**BROWNS FERRY NUCLEAR PLANT (BFN) - UNITS 1, 2, AND 3 -
LICENSE RENEWAL APPLICATION (LRA) - RESPONSE TO NRC REQUEST
FOR ADDITIONAL INFORMATION CONCERNING 4.7.7 TIME LIMITED
AGING ANALYSIS (TLAA) FOR CORE PLATE RELAXATION OF BOLTS (TAC
NOS. MC1704, MC1705, AND MC1706)**

RESPONSE TO NRC REQUEST FOR ADDITIONAL INFORMATION (RAI)
CONCERNING 4.7.7 TIME LIMITED AGING ANALYSIS (TLAA)
FOR CORE PLATE RELAXATION OF BOLTS

NRC RAI 4.7.7

BWRVIP-99: Figure 7-13. Radiation creep relaxation of shear stresses in springs of 20% cold worked 316 stainless steel along with modeling curves [Reference 2]. The dotted line represents 0.1 dpa which is equivalent to a fluence of $\sim 6-7 \times 10^{19}$ n/cm.

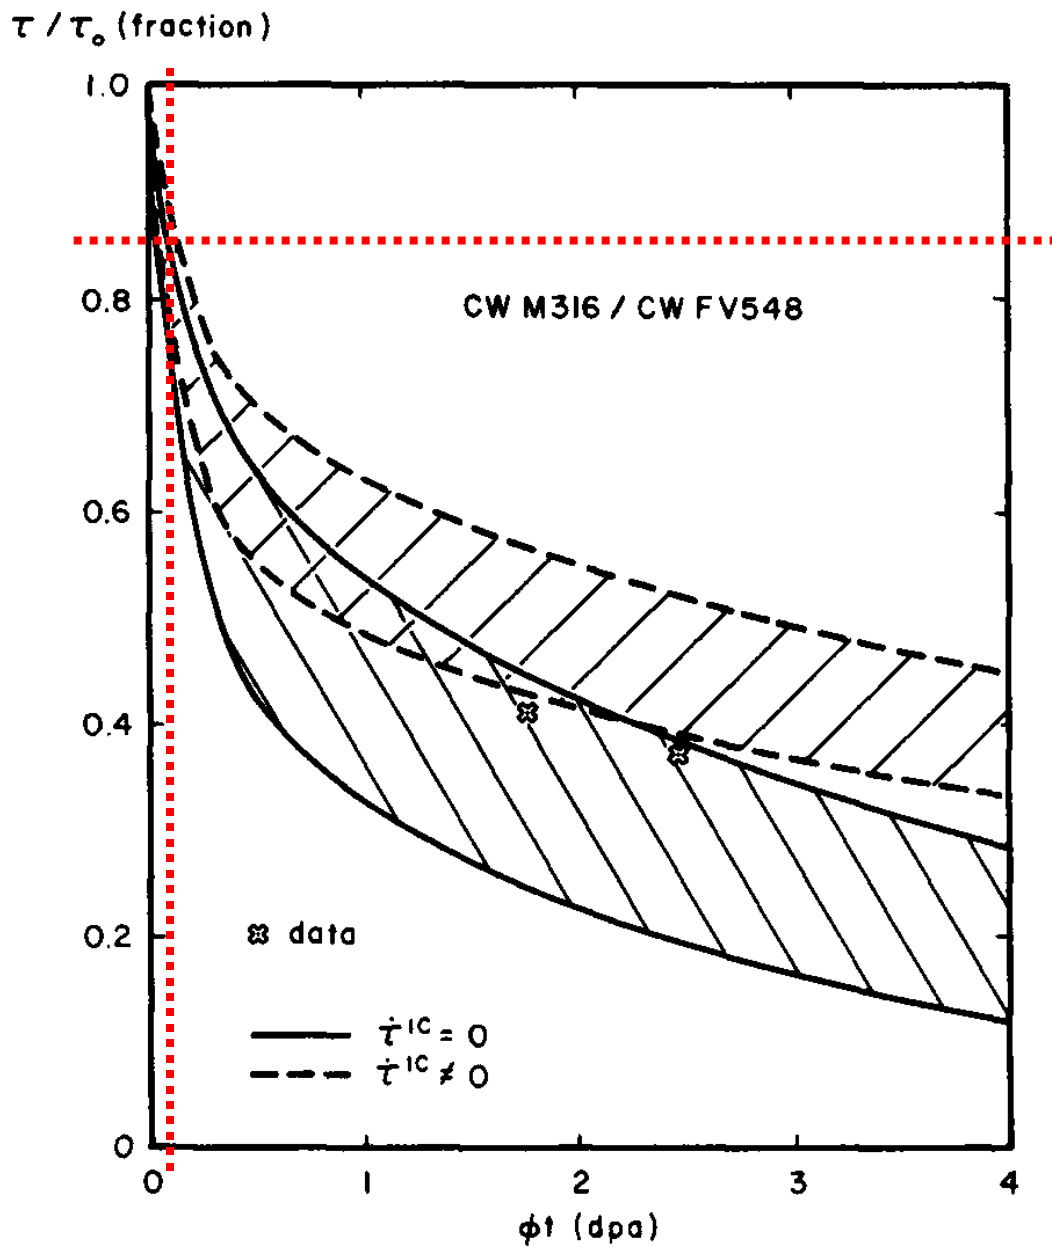
- (c) Provide a detailed description of the methodology and data used in Browns Ferry to perform the analysis as described in (b). Include the basis for the relaxation curves.

As stated earlier, the BFN calculation was performed based on BFN specific geometry, fluence and temperature. The calculation used the highest bolt end of life fluence as the basis of the reduced pre-load calculation for all of the bolts. The BFN fluence conditions and the expected relaxation made use of either GE methods or GE Design documents. The confidence in the relaxation value that was employed can be independently confirmed using other reports available to the NRC. Specifically, relaxation as a function of fluence has been presented in the BWRVIP-99 (Reference 1) in Section 7 of the report. This section deals directly with stress relaxation as a function of fluence. Figure 7-13 from BWRVIP-99 is attached; it shows data and modeling projections of relaxation versus fluence in displacements per atom (dpa). One dpa is equivalent to a fluence of $6-7 \times 10^{20}$ n/cm². It is noted that the data presented in the figure was measured on Type 316 stainless steel material. Comparison with Type 304 data is considered appropriate in that the two commercial

alloys have the same single-phase austenitic microstructure and crystal structure, with no precipitates present in either alloy. The only compositional difference is the addition of Mo to Type 316 to increase pitting resistance. The mechanical properties are essentially identical at 550°F. Therefore, the effects of irradiation on stress relaxation for both alloys is essentially the same.

Therefore, the fluence of interest for the BFN calculations is 10% of that or 0.1 dpa. The dotted lines depict that fluence level and one can see that the projected relaxation is less than 20%. This supports the value used in the analysis and, in turn, the GE Design Curve.
